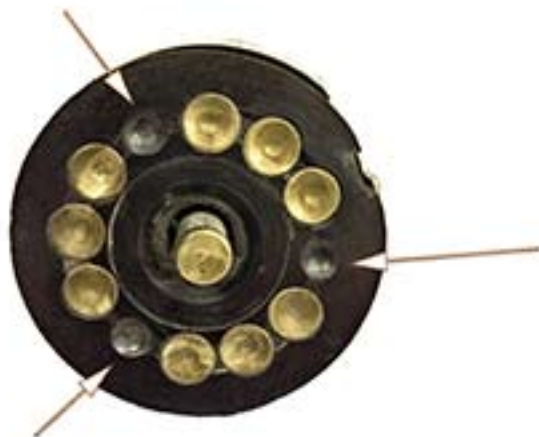
There are two problems with the wire disc. First the disc should be .315 (5/16") thick, but was made .350 or .035 too thick. When installed, the disc will be so **tight** against the brass ring it will not allow you to turn the handle in the steering wheel. **To correct**, file the back of the disc down by .035 (1/32") or grind the top of the lower cup down .035.

The second problem are the three Black OFF detents. They are .017 deeper resulting to make it harder to move out of the detent. Take a knife and scrap the edge of the hole to taper edge.
